NORTHEAST UTILITIES

February 26, 1990

Millstone Nuclear Power Station, Unit No. 3
Proposed Revision to Technical Specifications
Containment Pressure

Safety Evaluation for the Proposed
Design Changes--Containment Pressure

Fig. 1
 MILLSTONE-3 CONTAINMENT DEPRESSURIZATION
 INITIAL PRESS/TEMP = 14.2PSIA/80F
 (PSI(TEMP)) AND HEADER
 PRESSURE(PSIG) VS TIME(SEC)

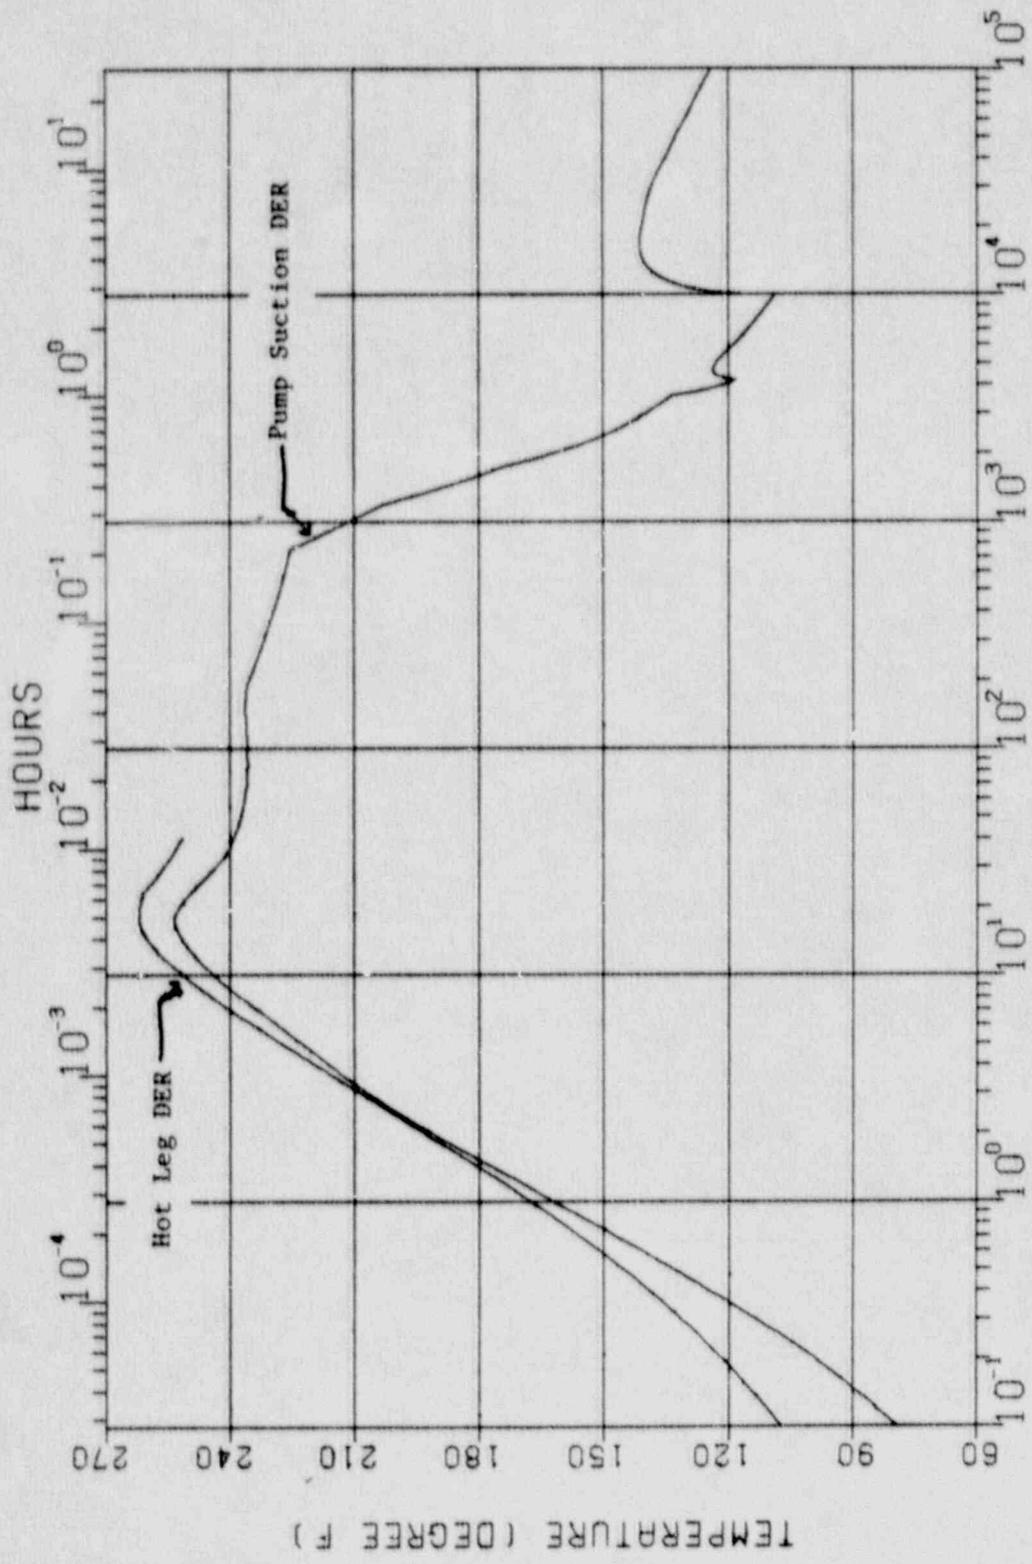
The revised containment pressure and temperature response for both the hot leg and pump suction DERs are shown in Figures 1 and 2, respectively. Figure 3 shows the long-term pressure transient following the pump suction DER.

The current analysis is based on the subatmospheric design of Millstone Unit No. 3, where all containment leakage terminates within 1 hour. The proposed change in pressure results in the attached post-LOCA pressure curve--Figure 1. The pressure drops to approximately 4 psig within 1 hour, but never goes subatmospheric, varying between 3 and 5.5 psig for the entire 30 days. To help compensate for the increased time release, the allowable Technical Specification leak rate, L_a , is being reduced from 0.9 percent per day to 0.65 percent per day. Conservatively, for calculating the dose to the public, the Standard Review Plan guidance of assuming L_a for the first day and $0.5 L_a$ for the remaining 29 days was assumed. For the control room and TSC calculations, a more reasonable assumption was made which recognizes the fact that Millstone Unit No. 3 still has the containment cooling systems typical of a subatmospheric containment. Thus, containment pressure is rapidly reduced compared to a standard atmospheric containment, for which the Standard Review Plan guidance was developed. An evaluation was performed to determine the fraction of L_a leak rate which would exist from 1 hour to 30 days after the break. The fraction was conservatively calculated to be $0.33 L_a$. Hence, the control room and TSC calculation assume $0.33 L_a$ from 1 hour to 30 days.

Figure 4

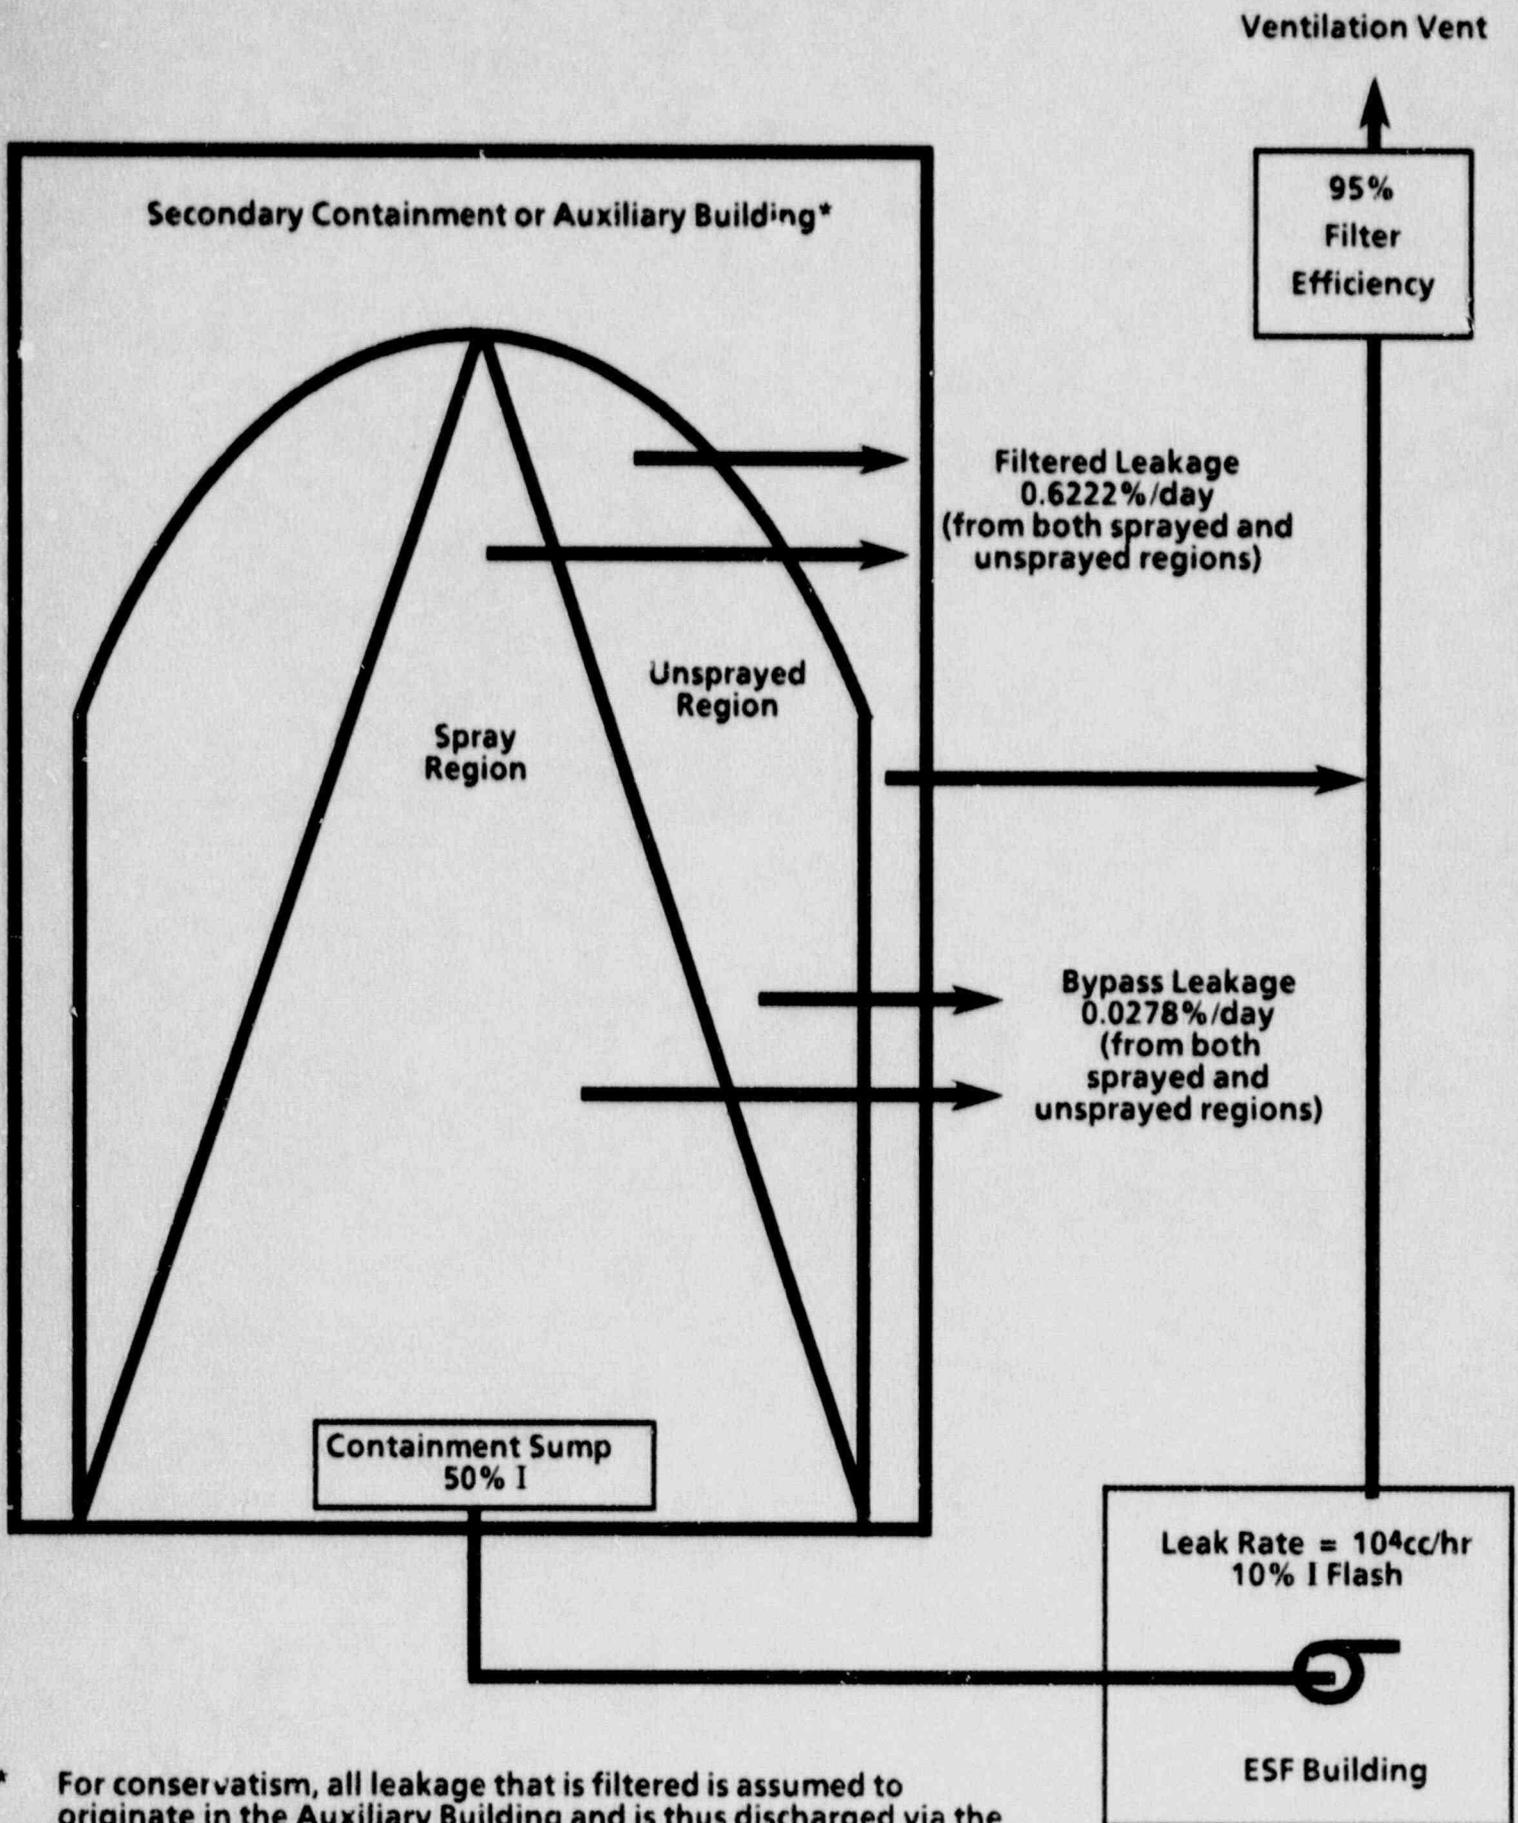
Figure 4 shows the pathways by which activity could be released from the Millstone Unit No. 3 containment following a LOCA or CREA. The CREA also includes a pathway due to primary-to-
